HONG KONG FIRE SERVICES DEPARTMENT

TECHNICAL GUIDANCE

**Application of BS 5839-1:2017 (Incorporating Corrigendum No. 1)
Fire Detection and Fire Alarm Systems for Buildings in Hong Kong**

June 2021

Figure A

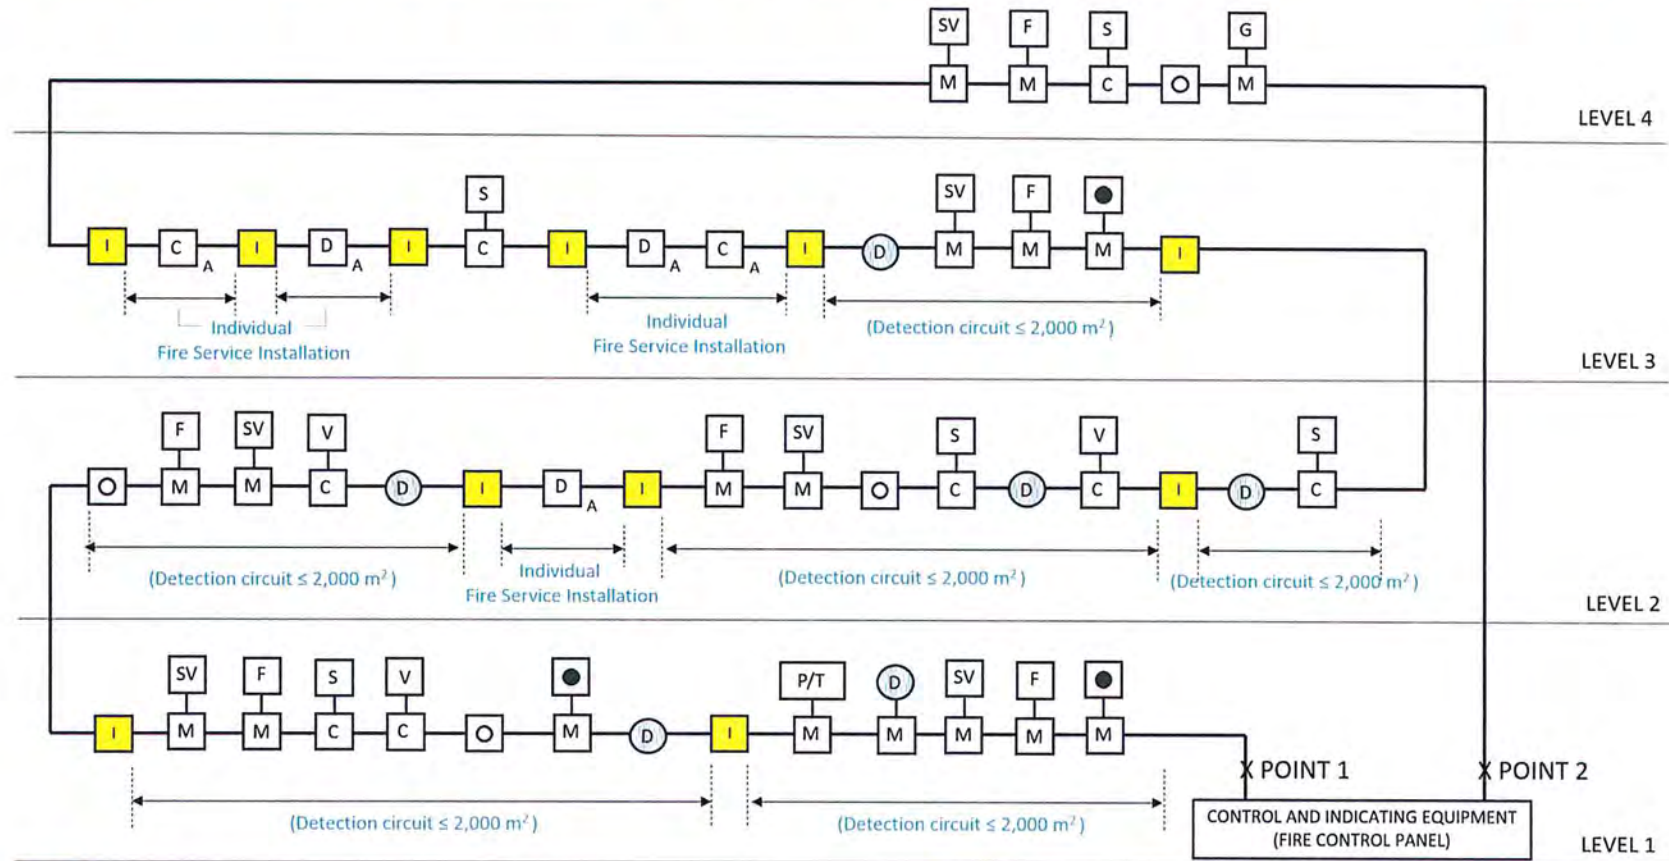
Clause 12.2.2 b) should be revised and read as

“A single short circuit or open circuit fault on an automatic fire detector and/or manual call point circuit should neither disable protection within an aggregate floor area of more than 2,000m² (calculated only on those portions of the premises installed with fire detectors), nor on more than one floor of a building.

For non-addressable system, a single short circuit or open circuit fault occurred in -

(i) manual call point circuit shall not disable protection on more than one floor of the building;

(ii) a detection circuit shall not disable protection within an aggregate floor area of more than 2,000 m² (calculated only on those portions of the premises installed with fire detectors) or on more than one floor of the building.”

Clause 12.2.2 c) should be revised and read as

“Two simultaneous faults on an automatic fire detection circuit including fire alarm devices, manual call points and fire detectors or a combination of these, should not disable protection within a gross floor area greater than 10,000 m².”

Note: This clause is to clarify the calculation method of 2,000 m². (See Figure A – Circuit Arrangement For Automatic Fire Detection Circuit (Addressable System))

Note: This clause is to clarify the calculation method of 10,000 m². (See Figure A – Circuit Arrangement For Automatic Fire Detection Circuit (Addressable System))

CASE 1 – Protected Area ≤ 2,000 m²

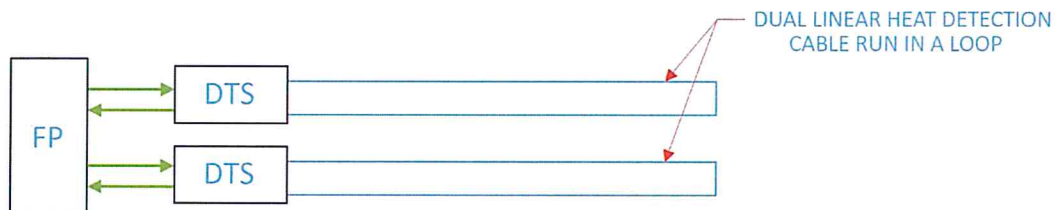
**The following new Clause 12.2.2 m)** should be added

(i) For protection area not exceeding 2,000 m², a single short circuit or open circuit fault on the linear heat detection cable should not disable protection within the area of 2,000 m² by providing linear heat detection cable arrangement as shown in figure below.

(ii) For protection area exceeding 2,000 m², duplicate linear heat detection cables with its associated control panels, should be provided with configuration as recommended by manufacturer, to form a complete redundancy as shown in figure below.”

Note: This clause is to add requirements on linear heat detectors.

Figure 1 – For Detectors inside Floor Voids

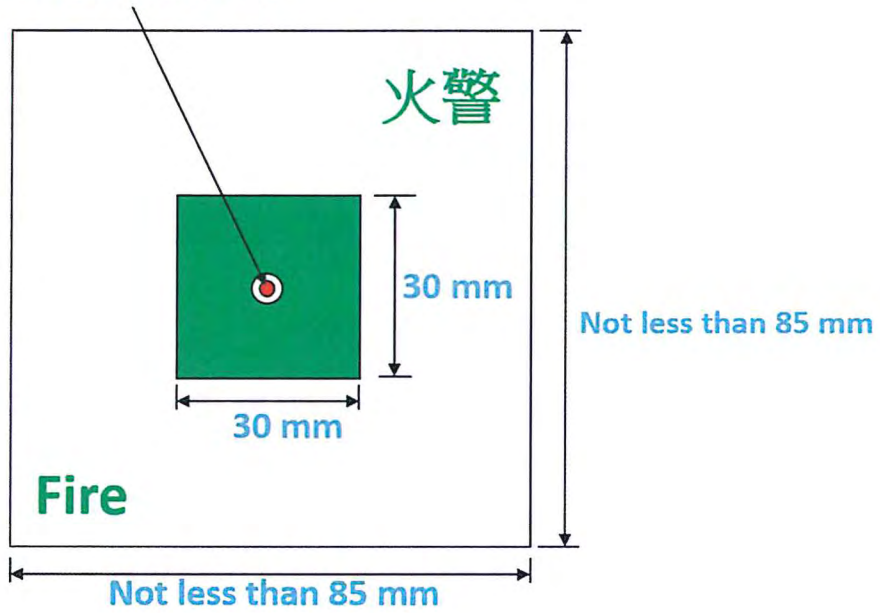
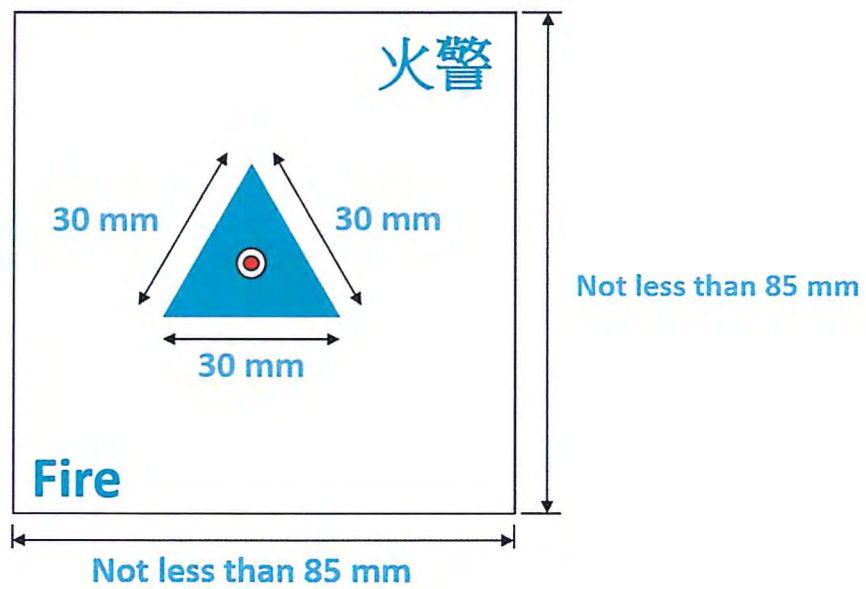
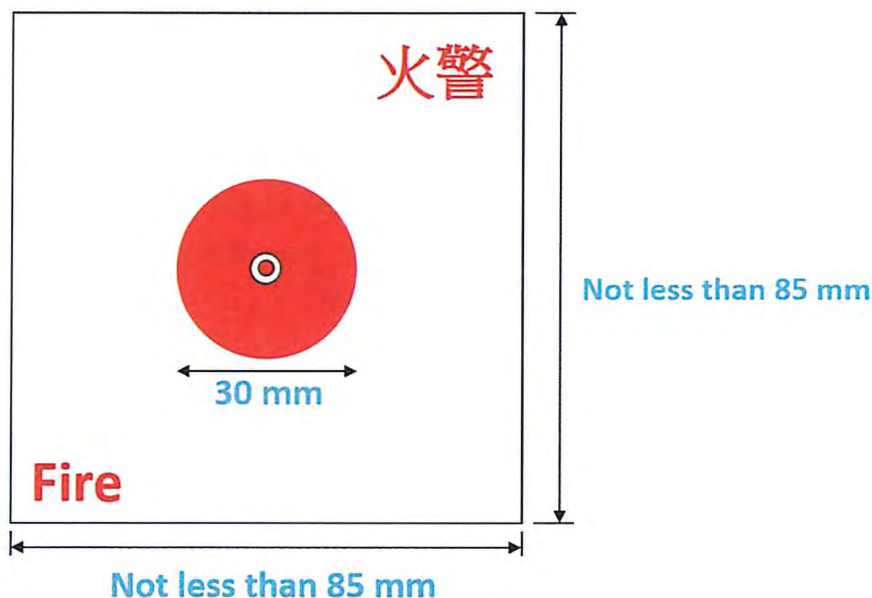
Clause 13.2.5 Para. 1 should be revised and read as

1. The colours for the plate, the graphic pattern and the wording should be suitably chosen so as to provide luminous contrast for the purpose of clear identification at a distance.
2. The indicating lamp should be red in colour.
3. The height of English letters and Chinese characters should not be less than 10 mm and 15 mm respectively or should follow the latest specifications issued by the Director of Fire Services from time to time.
4. The designs of remote indicating lamp plates for detectors in respective locations, i.e. floor voids, ceiling voids and lockable rooms, should follow the relevant graphic pattern illustrated below:-
 - (a) Figure 1 – For Detectors inside Floor Voids
 - (b) Figure 2 – For Detectors inside Ceiling Voids
 - (c) Figure 3 – For Detector inside Lockable Rooms”

Note: This clause is to meet local requirements for remote indicator labelling and clarify the requirement for the provision of remote indicator. For addressable system, remote indicator lamp is not required.

Figure 11 c) – Ceilings : Cells formed from joists [see 22.3k) and 22.3l)]

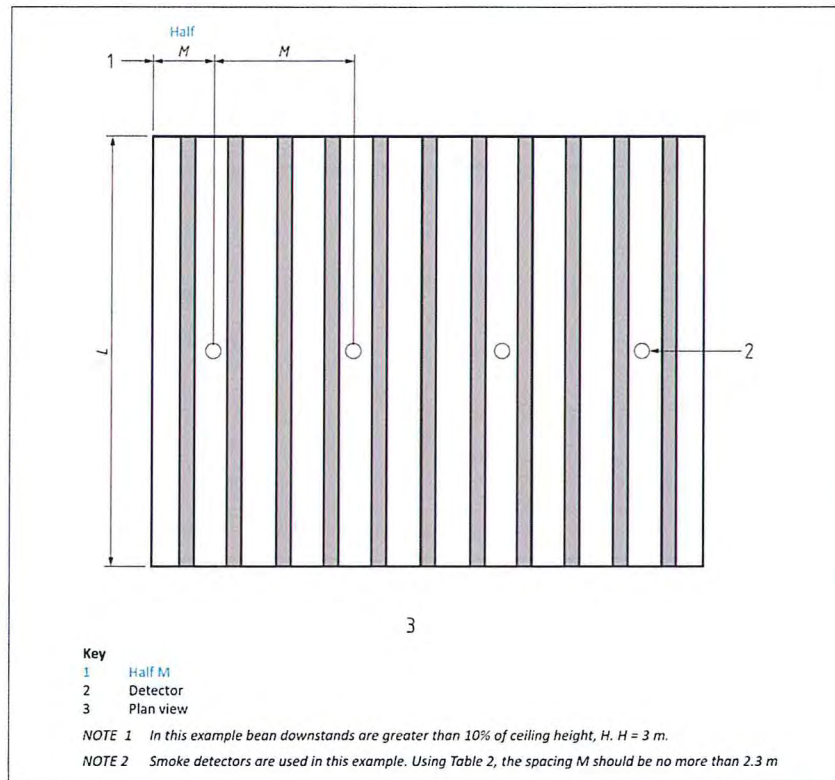
**Figure 11 c) of Clause 22.3 l)** should be revised and read as
